Response to RC 1:

Summary

This paper compares different sea ice type products currently available to the community. The products are based on passive microwave data, scatterometer data (C or Ku band), or a combination of both. The products have been developed empirically via training data. The type fields are inter-compared and evaluated against a widely-used sea ice age product and SAR retrievals. The products perform better in mid-winter than in early or late winter when melt/re-freeze may occur. Ku-band scatterometer generally is better at type discrimination. Combination of passive microwave and scatterometer data can yield better performance at times, but not in all situations.

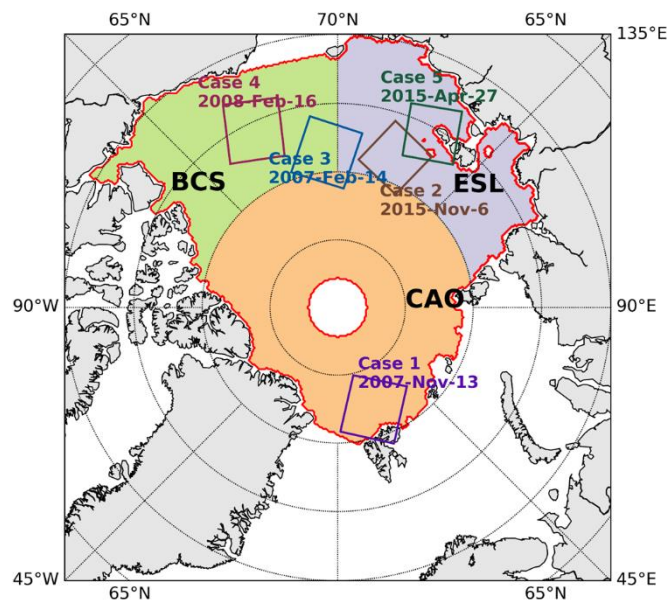
Lines 159/160: "the geolocations and acquiring dates of the SAR images" --> "the location of the five SAR images". There is no acquisition date given in Figure 2. Hence the acquisition dates are missing and the time difference with respect to the sea ice type products the SAR images are compared to is unknown. This needs to be included in the revised version of the manuscript.

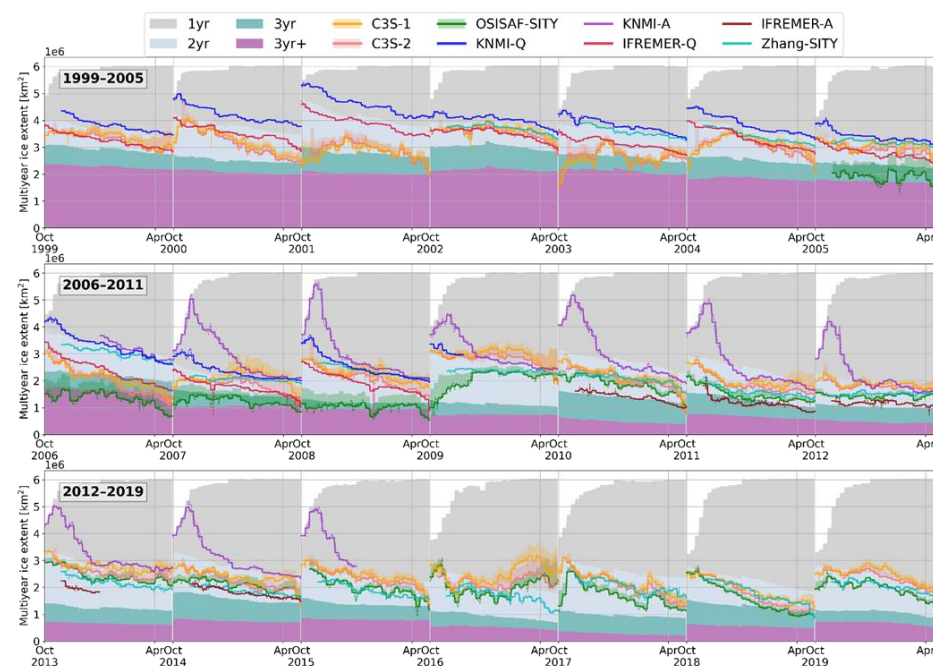
- Here, in this line you write "extent is calculated by general extent of pixels", in line 176 you write "MYI extent is estimated as the integral of all pixels specified ..." . Both formulations are not to the point and not specific enough. I recommend to re-phrase in both cases along the lines "We computed the MYI extent as the sum of the area of all grid cells classified as MYI."

- In this context I have two questions. 1) Did you use a common land mask? Or is this not required because the region of interest that is delineated by the red line in Fig. 2 is clear of any land influence? 2) Did you take into account that the grid cell area is only a constant in the EASE grid projection while it changes with latitude for the products in polar-stereographic projection? If you did not take this into account yet you must correct your computations.

Reply: Agree. In the revision, we added a new section regarding the estimation of MYI extent, Section 3.1 “Estimation of MYI extent”. Details can be found on L294-302, the sentences start with:

“For the inter-comparison, the Arctic MYI extent is calculated from the respective SITY and SIA products ...”

Reply: Thank you for the advice. In the revised manuscript, we calculated the weekly averaged MYI extent from the SITY products with the NSIDC-SIA product. All the relevant numbers have been modified accordingly. Plots of the weekly averaged MYI extent was presented in Fig. 4. The modified figure is as below:

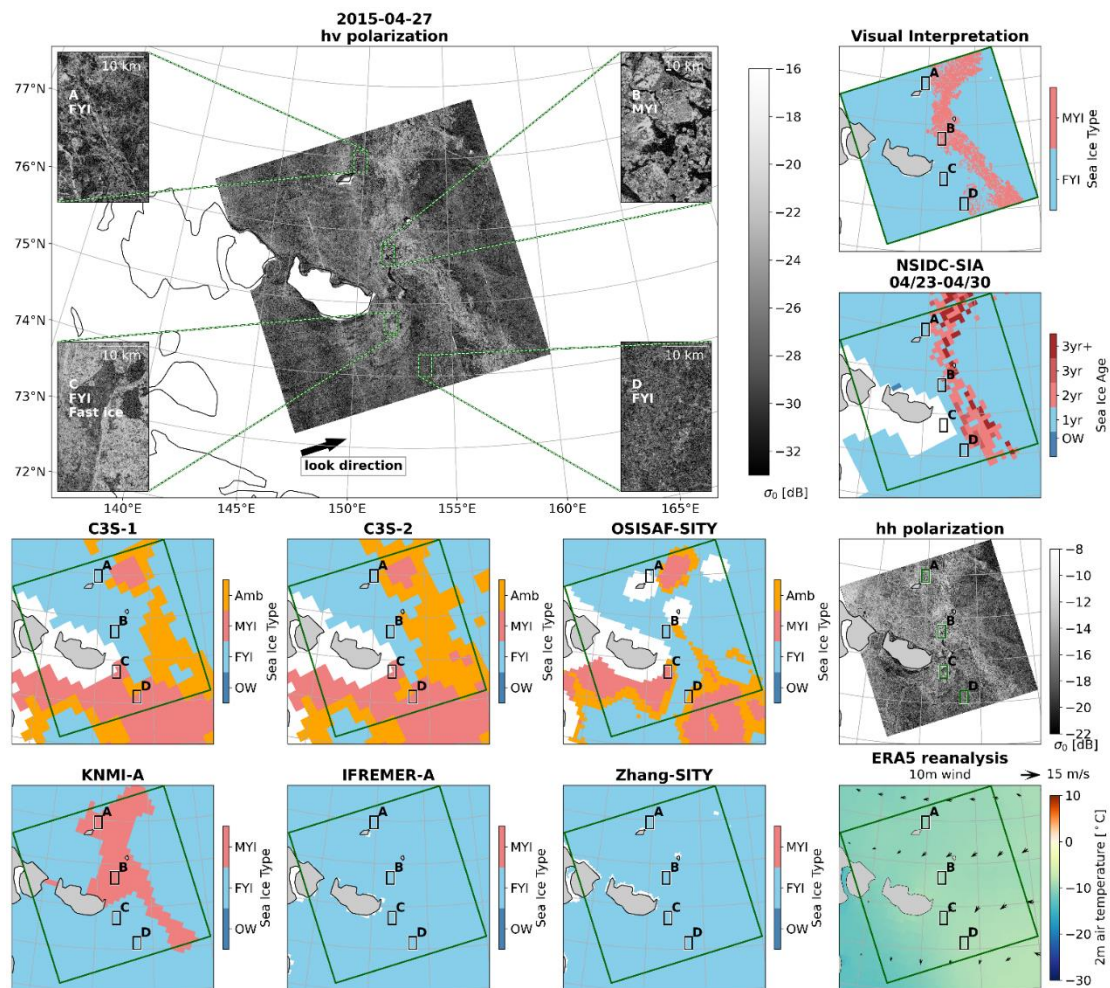
Lines 306-311: I would say this is a classical example where the NSIDC-SIA is one of the more useful data sets here. Looking carefully it is clear that regions C and D are both FYI. You can check the minimum extent end of summer 2014 please to check whether in that area close to Severnaya Zemlya sea ice survived the summer melt. I doubt so. Hence these two areas are located within the landfast sea ice (FYI) cover that develops there usually - as is also well backed up by a sea ice drift speed of zero. While I could agree that region B is in fact MYI I doubt that region A is MYI. This is certainly an area where i) deformation and ii) deep snow plays a significant role in shaping the different microwave signals contributing to the (every) sea ice type classification.

Reply: Thank you for the comment. We agree that this case actually shows typical case of landfast ice (FYI) mixed with MYI. In the original manuscript, our interpretation about areas A and B is consistent with you (A as FYI and B as MYI). Regarding Area C, we agree that it should be landfast FYI instead of MYI. Interpretation results, the statistics and the texts were modified accordingly in the revision. The modified texts can be found in L542-L549. The modified figure (Fig.13) is shown as below.

“The MYI distribution pattern of KNMI-A resembles the SAR image except for a slight overestimation of MYI in the northern part of the image (area A) and nearly the island, which may be caused by ice deformation. The Kappa coefficient and OA is the largest for KNMI-A in this case. IFREMER-A and Zhang-SITY both completely ignore the MYI pack, and this error lasts for the whole winter (maps not shown). C3S-SITY (C3S-1 and C3S-2) and OSISAF-SITY manage to identify FYI in area A, and sporadically capture an elongated MYI feature northeast of the image (partly classified as Amb). However, they underestimate MYI in area B and overestimate MYI in the southern part (areas C and D), which leads to a near-zero level Kappa coefficient. NSIDC-SIA clearly captures the elongated MYI feature in this case though has slight underestimation of MYI in area B.”
